41 W CHURCH STREET DOWNTOWN HISTORIC DISTRICT

A Major Certificate of Appropriateness request to alter the first floor storefront with new operable doors, repairs will be made to the second floor vitrolite glass panels and awning. No change is proposed to the footprint or height of the existing structure.

EXISTING FLOOR PLAN AT SIDEWALK

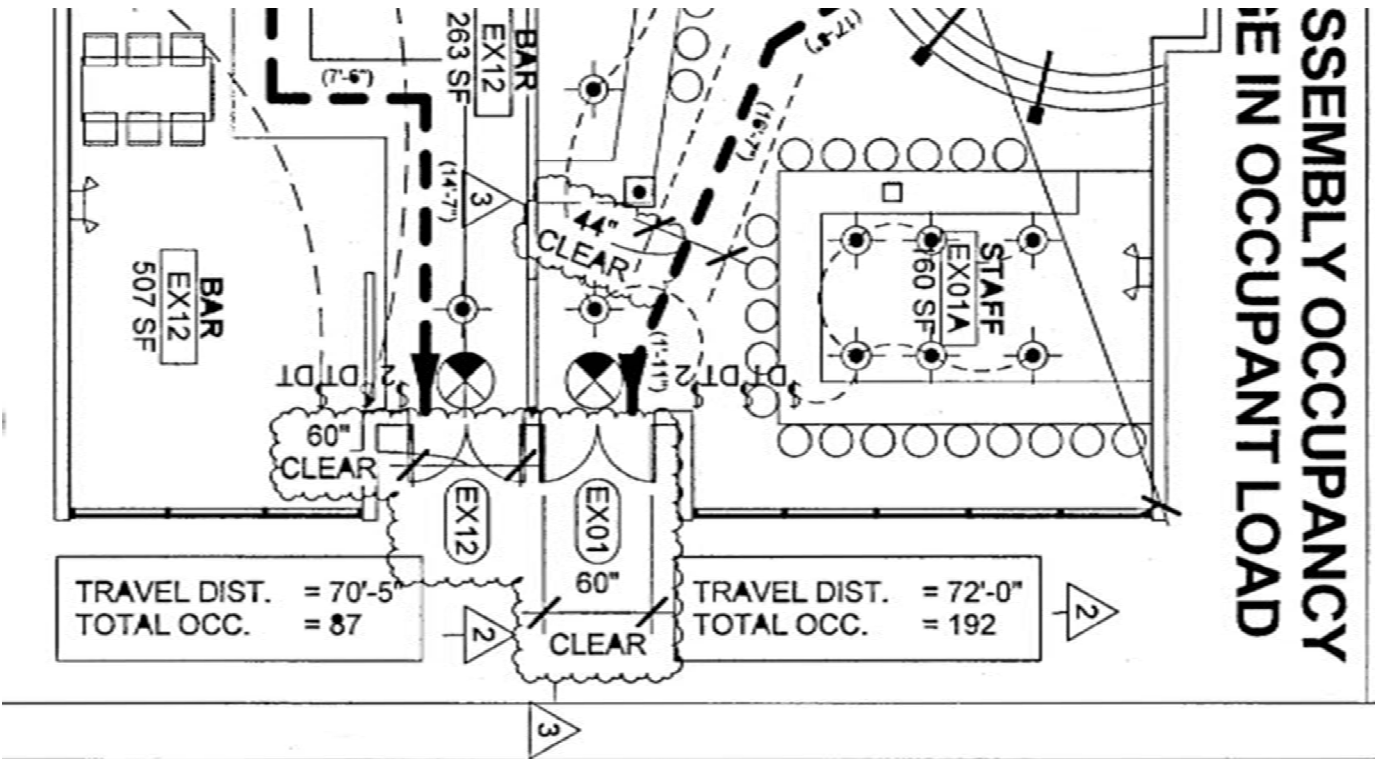
Existing storefront line to remain the same. No change to recess and door locations. The west (left) double doors are not original but can remain.

EXISTING ELEVATION

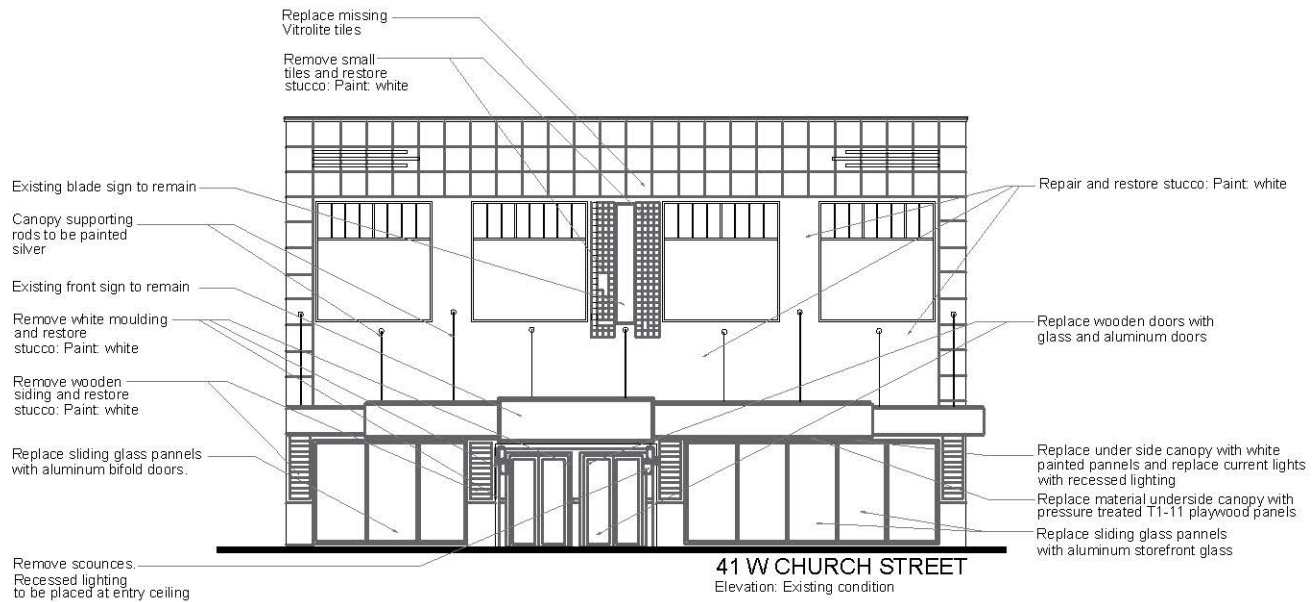
The storefront and doors on the first level will be replaced. The canopy will be repaired and the ceiling replaced with new lighting. The canopy support rods will be painted. The current white stucco portions will be repaired and missing black vitrolite panels will be replaced.

PROPOSED FACADE

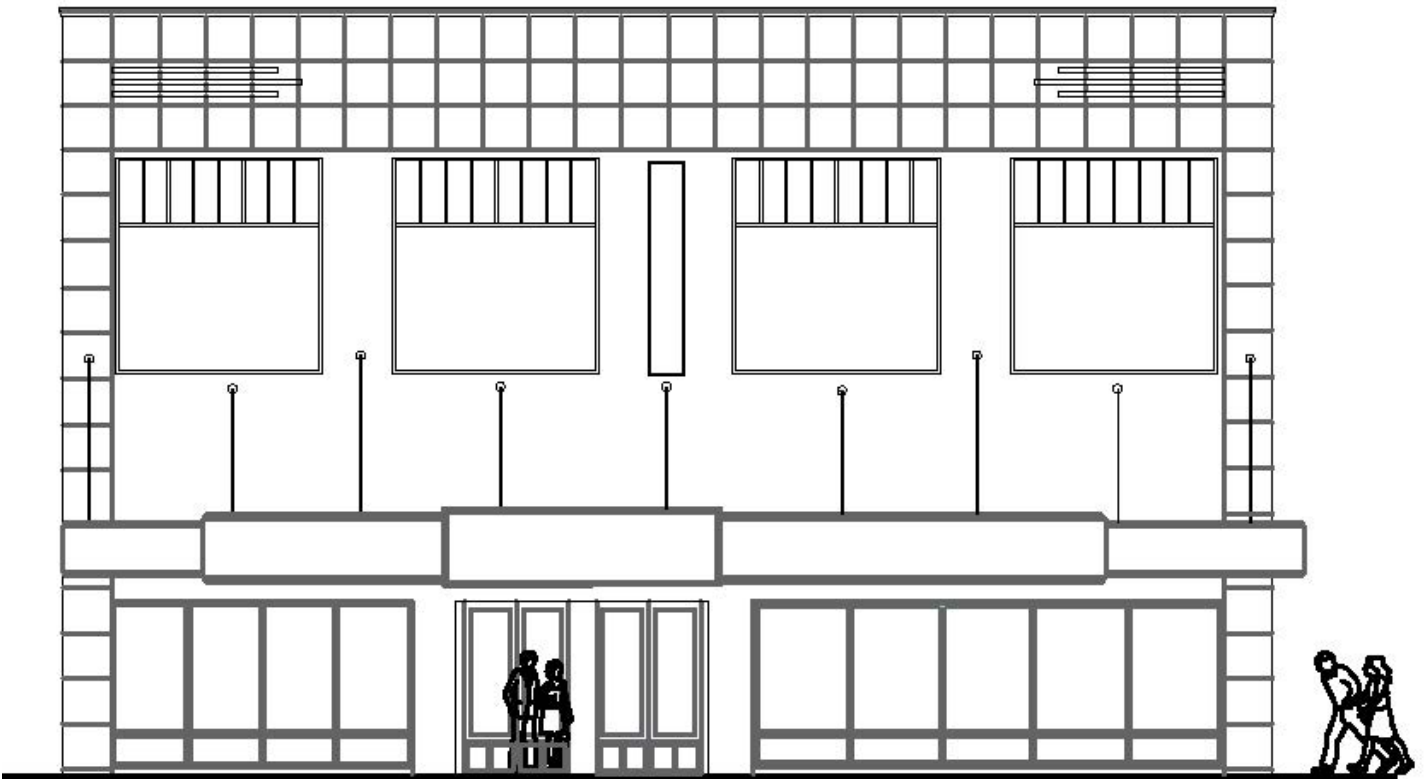
4. The applicant confirms the material of the canopy ceiling with staff prior to installation.
5. Final specifications for the sliding/bifold doors in the storefront are reviewed by staff through the minor review process.

Storefronts are bifold sliding doors but when closed match proportions of a typical storefront. New central doors carry the bulkhead line across the façade. Vitrolite panels down the exterior to the first floor connect the 2 levels. Central portion of second level is all white for simplicity and to clean up past repairs.
